ENGINE - H.P. COMPRESSOR - STAGE 9 COMPRESSOR ROTOR BLADE WITH CUT BACK PLATFORM -
CATEGORY CODE 5 - MOD.ENG-72-0109

V2500-ENG-72-0109

Location of stage 9 compressor blade
Fig.1

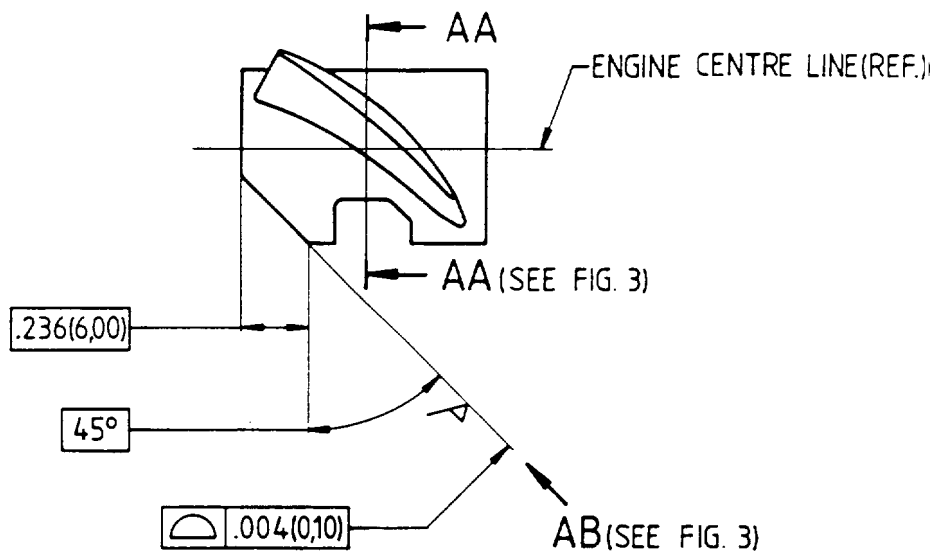
REMOVE 6A3253 BLADE AND
INSTALL 6A4367 BLADE

REMOVE 6A3251CO1 AND
6A3251CO2 BLADES AND
INSTALL 6A4365CO1 AND
6A4365CO2 BLADES

REMOVE 6A3252 BLADE AND
INSTALL 6A4366 BLADE

H.P. compressor stage 9 left-hand locking plates
Fig.2

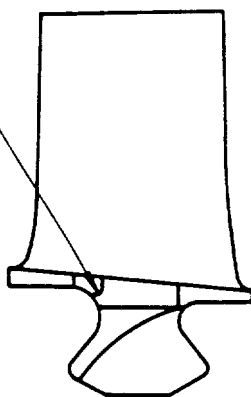
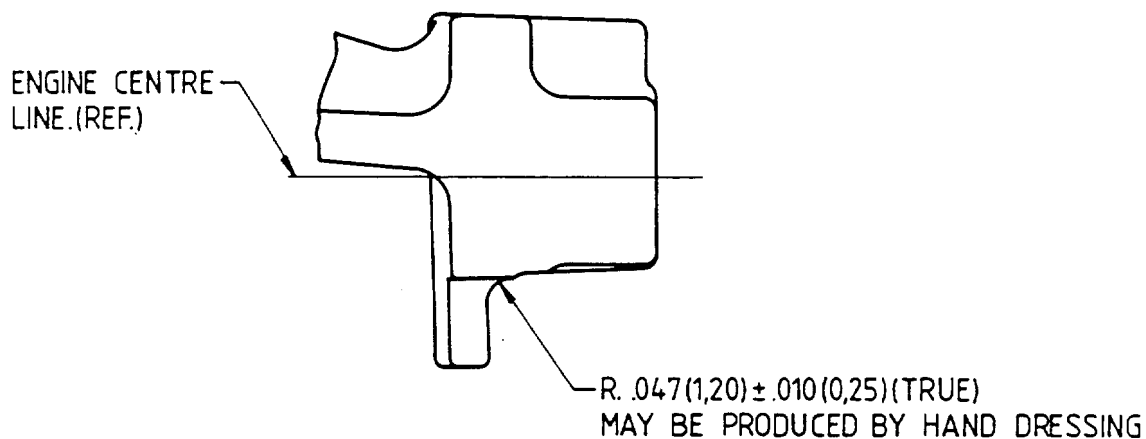
An additional dressing operation is required to radius the cusp created on the L.H. locking blade by the rear edge of the blade dovetail and the trailing corner at the locking slot.

FULL LENGTH OF THIN SECTION
PRODUCED BY MACHINING TO BE
REMOVED BY $R. .030(0,75) \pm .010$
(0,25) (TRUE).
THIS RADIUS MAY BE PRODUCED
BY HAND DRESSING.

H.P. compressor stage 9 left-hand locking blades
Fig.3

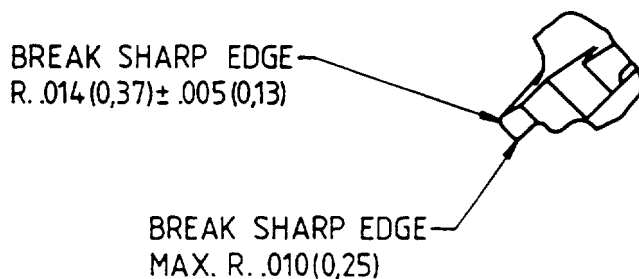
SECTION AA(SEE FIG. 2)

VIEW → AB(SEE FIG. 2)

H.P. compressor stage 9 right-hand locking blades
Fig.4

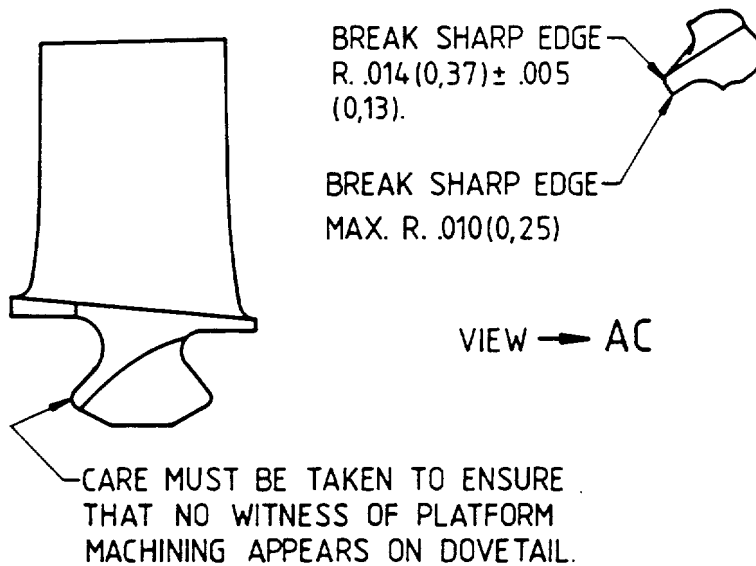
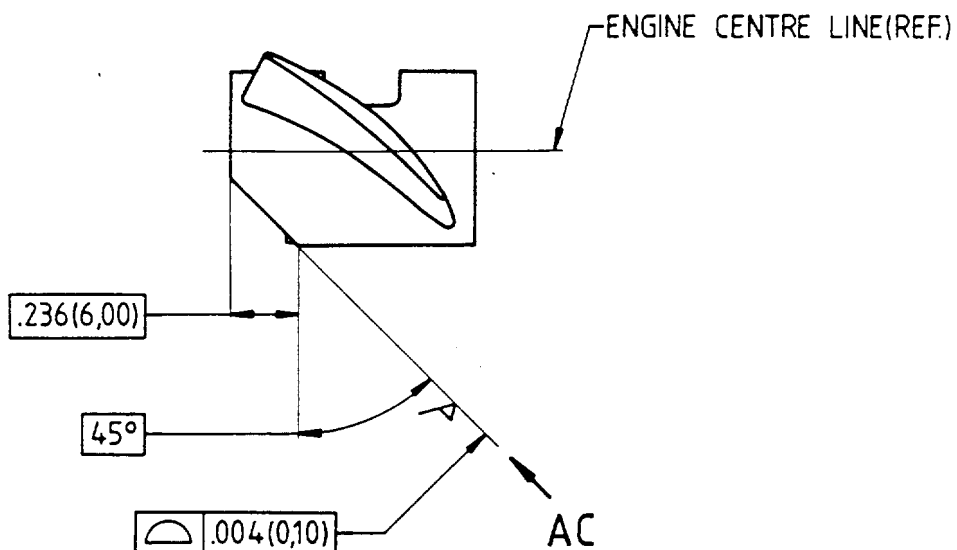
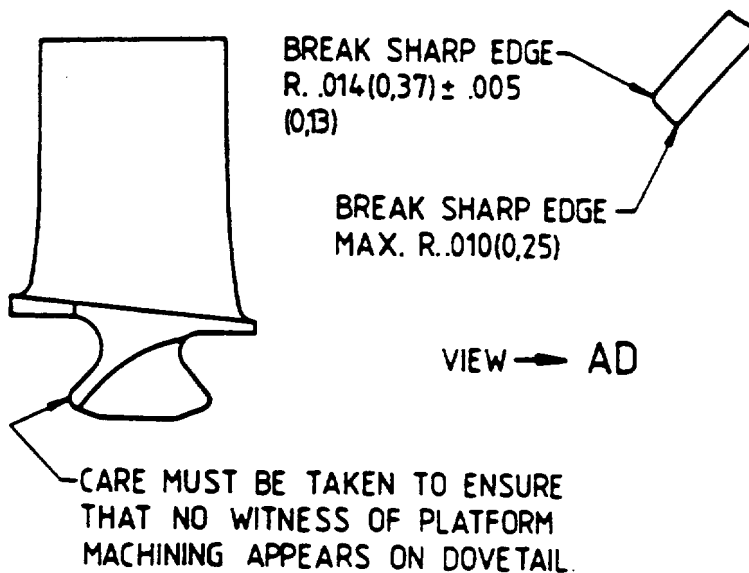
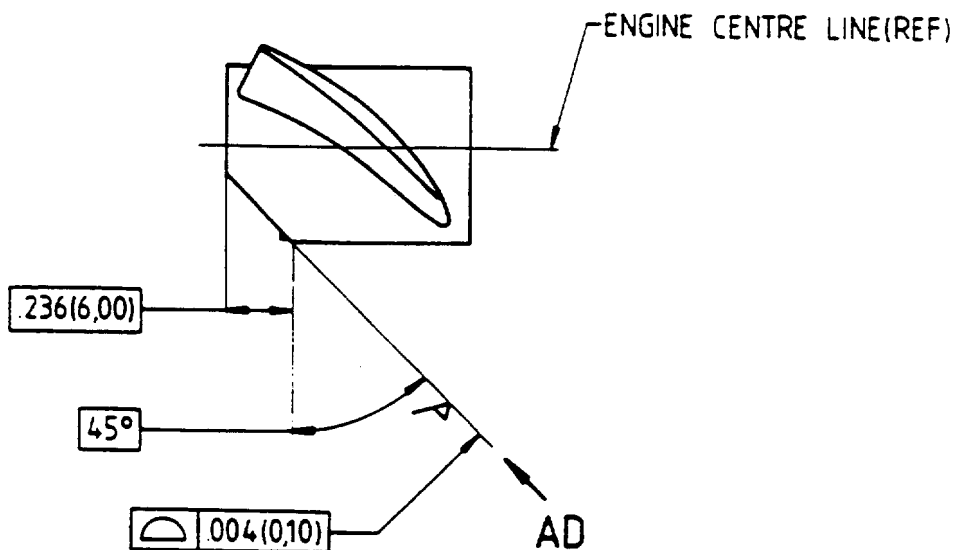
This Service Bulletin introduces stage 9 H.P. compressor rotor blades with the platform cut back at the trailing edge corner on the pressure side of the blade.

Procedure	Supplementary Information
(a) Install fixture onto the table of an applicable grinding machine	Use IAE 3R19009 grinding fixture, 1 off
(b) Set height of grinding fixutre	Use a 0.1in. (2,54 mm) slip
(c) Install blade onto fixture	
(D) Cut back blade platform where shown	See Figures 2, 4 or 5 as applicable
(e) Remove sharp edges	See Figures 2, 3, 4 or 5 as applicable. Use basic workshop tools
(f) Remove material to form radii on L.H. locking blade	See Figures 2 and 3 as applicable. Use basic workshop tools
(g) Measure the dimensions	See Figures 2, 3, 4 or 5 as applicable

Reworking of existing stage 9 rotor blades
Fig.6

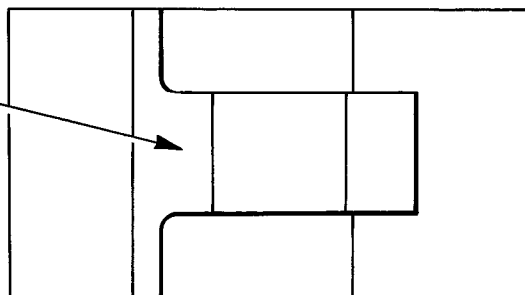
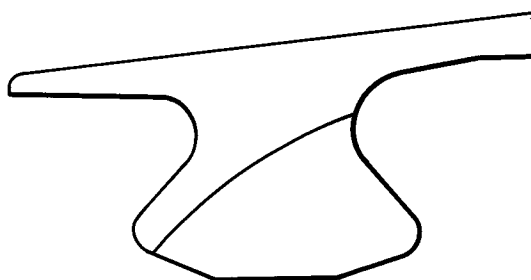
IF ALTERNATIVE METHOD
OF BLADE IDENTIFICATION
IS CHOSEN, ENGRAVE
THE SYMBOL  HERE
